Re: FirstEnergy Nuclear Operating Company's (FENOC's) Wastage Event Report

We are writing to follow up on a telephone conversation we held with Mr. Matthews in April 2007 regarding a report prepared for FENOC by Exponent Failure Analysis Associates and Altran Solutions Corporation. The report was titled "Review and Analysis of the Davis-Besse March 2002 Reactor Pressure Vessel Head Wastage Event" ("Wastage Event Report").

**ATTACHMENT A**  
**Flange Leakage Examples**

**1998, 1999, and 2000 Inspections of Flange D10**

**Figure 4: 1998 Flange Inspection (Beneath D10)**

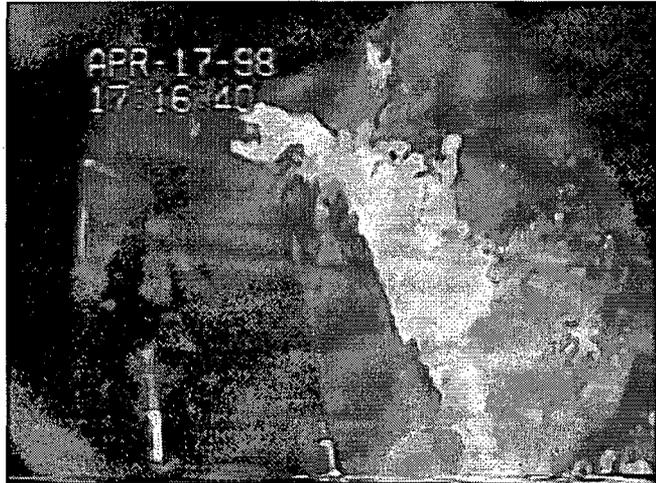
<sup>4/</sup> Please compare Figure 1 of Attachment A (video capture from 1993 Davis-Besse flange inspection showing flange leakage at flange E9) with Figure 2 of Attachment A (flange interface of D10 flange in 2000) and also with Attachment B (video captures from the 1998, 1999, and 2000 flange inspections, showing a consistent pattern of boric acid left on the nozzle surface from outage to outage). The remainder of the 1998, 1999, and 2000 flange inspection video records show nothing like the flange leakage found at Davis-Besse previously, i.e., nothing similar to what is shown at Figure 1 of Attachment A.

<sup>5/</sup> As stated above, we have concluded that new boric acid on the reactor head in 2000 was not from flange leakage. There are multiple bases for this conclusion. With respect to the Wastage Event Report, the most telling reason is the following: The Wastage Event Report suggests that there was substantial flange leakage from the D10 flange, which corresponds to nozzle 31, a nozzle relatively close to nozzle 3. During the 1998, and 2000 refueling outages, FENOC recorded video inspections of the control rod drive mechanism flanges. The video records of those inspections show no indications of recent flange leakage. In 1999, in an effort to account for unidentified reactor coolant system leakage, the flanges were inspected during a mid-cycle outage. Documentation from that inspection states that no flange leakage was found. See PCAQR 1998-0649, Corrective Action Items 1, 2, and 3. Thus, none of the three flange inspections that are relevant to the Wastage Event Report's assumption about the source of the boric acid showed new indications of leakage. Although images from the D10 flange inspection do show a pattern of boric acid on the D10 nozzle, that pattern is essentially
